COMPANY:	ASHDOWN				
TITLE:	MiBASS V2.0				
DRAWN: <Drawn By>	DATED: <Drawn Date>	CODE: <Code>	SIZE: D	DRAWING NO: <Drawing Number>	REV: <Revision>
CHECKED: <Checked By>	DATED: <Checked Date>				
QUALITY CONTROL: <QC By>	DATED: <QC Date>				
RELEASED: <Released By>	DATED: <Release Date>	SCALE: <Scale>		SHEET: 1 OF 1

BACK

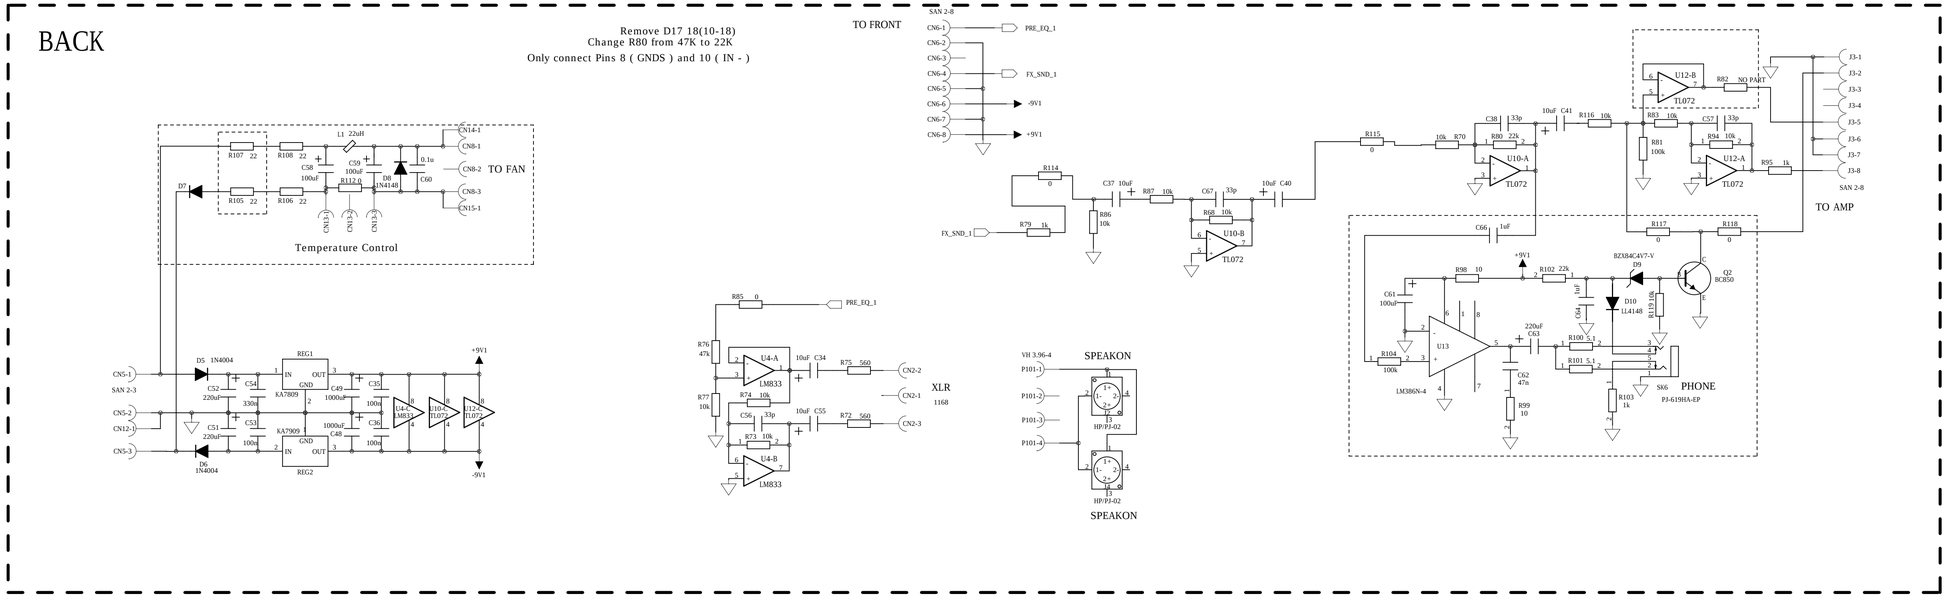
Remove D17 18(10-18)
Change R80 from 47K to 22K
Only connect Pins 8 (GNDS) and 10 (IN -)
